RESPONSES TO
NRC QUESTIONS
ON THE
MONTICELLO PUAR

PREPARED BY
NUTECH ENGINEERS, INC.
SAN JOSE, CALIFORNIA

PREPARED FOR
NORTHERN STATES POWER CO.

NRC QUESTION ON MONTICELLO PUAR
HYDRODYNAMIC LOAD RESPONSE

Figure 9 - 4"φ

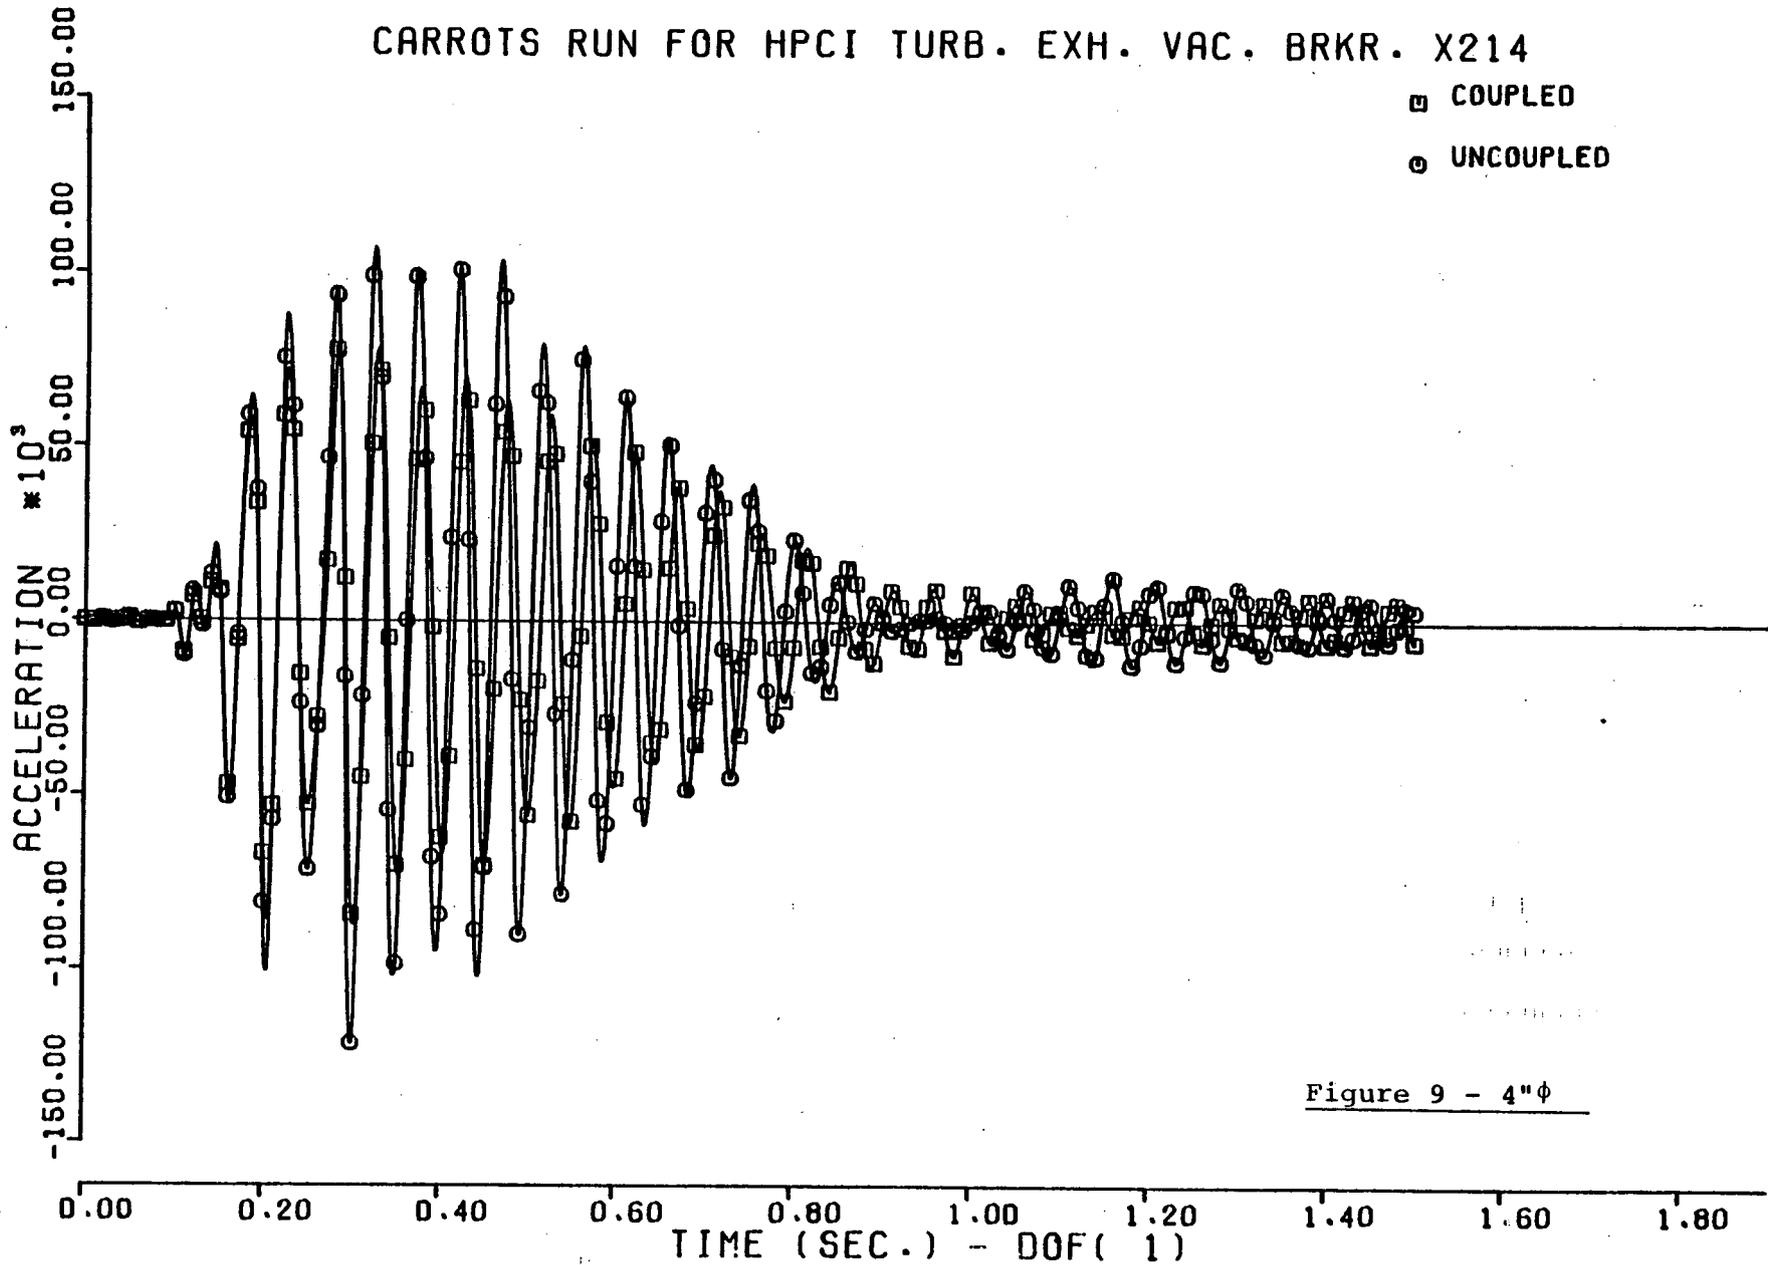
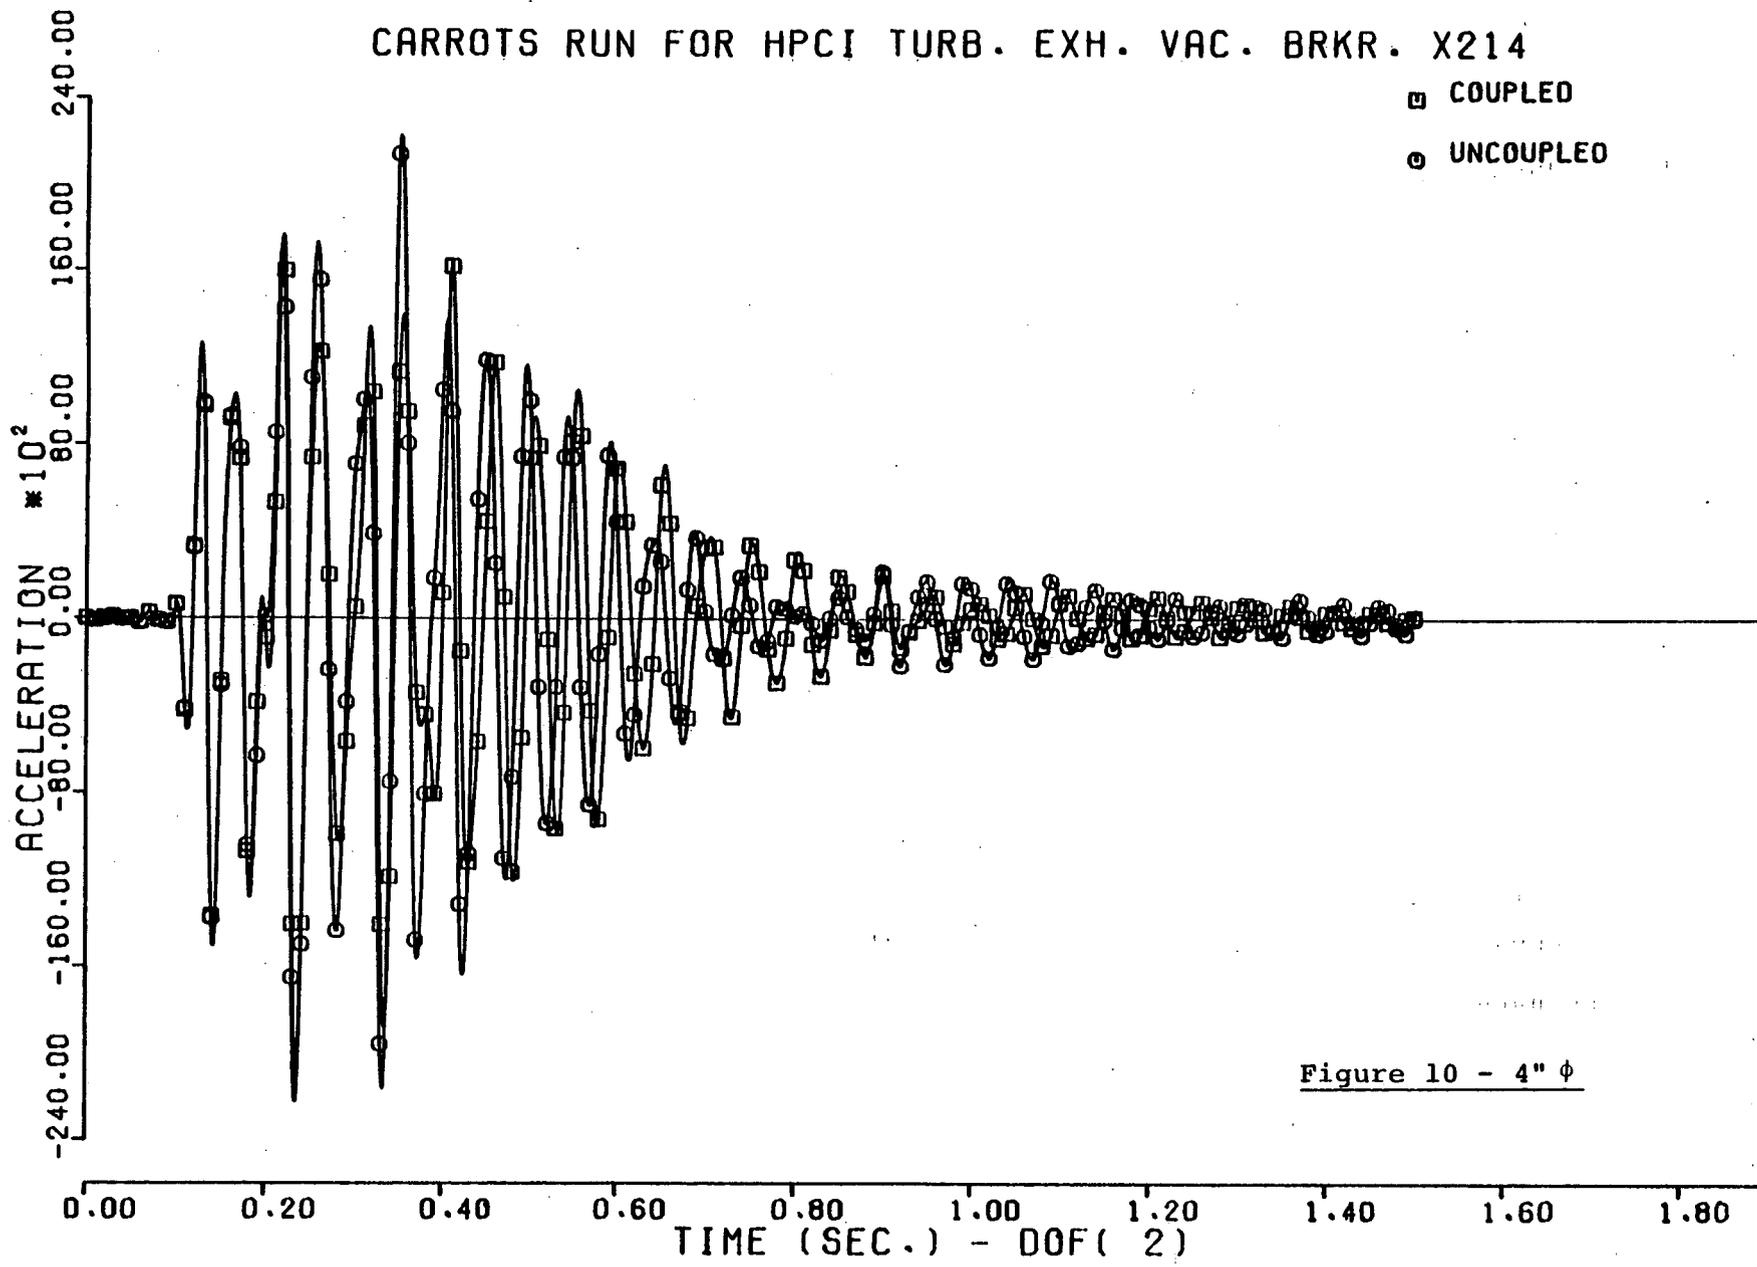
ITEM 12: The computer code CMDOF has been used in the torus attached piping analysis for all plants that utilized NUTECH as their contractor. With regard to the code provide the following information:

- 1) Theoretical background of CMDOF computer program
- 2) Program verification
- 3) Applicability of the computer program to the torus attached piping analysis.

To illustrate the effect of pipe size on coupling, four typical piping systems were examined and the coupled and uncoupled time histories plotted together. These time histories include both the smallest (2") and larger (20") systems analyzed. Listed below are the figure numbers and the corresponding line size.

Figure 4-8	2" diameter
9-13	4" diameter
14-18	6" diameter
19-21	20" diameter

These plots confirm the expected variation of coupling benefit with pipe size.
